UNITED STATES PATENT AND TRADEMARK OFFICE

APPLICATION NO.	FILING DATE	FIRST NAMED INVENTOR	ATTORNEY DOCKET NO.	CONFIRMATION NO.
10/796,628	03/08/2004	Han Cheol Ryu	2013P157	2826
8791	7590	04/28/2006	EXAMINER	
BLAKELY SOKOLOFF TAYLOR & ZAFMAN 12400 WILSHIRE BOULEVARD SEVENTH FLOOR LOS ANGELES, CA 90025-1030			OLSEN, ALLAN W	
			ART UNIT	PAPER NUMBER
			1763

Office Action Summary	Application No. 10/796,628	Applicant(s) RYU ET AL.	
	Examiner Allan Olsen	Art Unit 1763

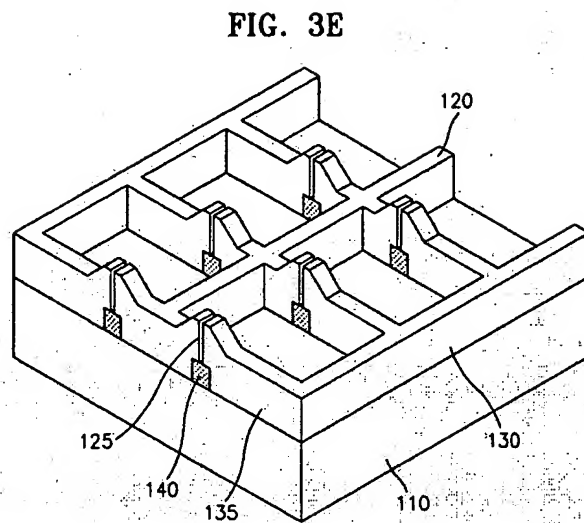
The drawings are objected to because in Figure 2 the first electrode 125 and the second electrode 135 that are shown as components of an IDC 150 are from two different IDC's, as such, the indicated grouping of components does not constitute an IDC. Also, as in the previous Office action, the drawings are objected to for failing to comply with 37 CFR 1.84(p)(4) because reference character "150" has been used to designate an IDC in figure 4C whereas in figure 4A "150" does not point to the IDC of Figure 4C. The depiction of IDC 150 in figure 4C is close-up of figure 4B, which is a close-up of figure 4A. In Figure 4A, the reference number 150 points to a region that is outside the region that is detailed in figure 4B. Below is applicant's figure 3E to which the examiner has added the reference character 150 - twice - one reflecting the representation of figure 4A and the other reflecting 4C.

Corrected drawing sheets in compliance with 37 CFR 1.121(d) are required in reply to the Office action to avoid abandonment of the application. Any amended replacement drawing sheet should include all of the figures appearing on the immediate prior version of the sheet, even if only one figure is being amended. The figure or figure number of an amended drawing should not be labeled as "amended." If a drawing figure is to be canceled, the appropriate figure must be removed from the replacement sheet, and where necessary, the remaining figures must be renumbered and appropriate changes made to the brief description of the several views of the drawings for consistency. Additional replacement sheets may be necessary to show the renumbering of the remaining figures. Each drawing sheet submitted after the filing date of an
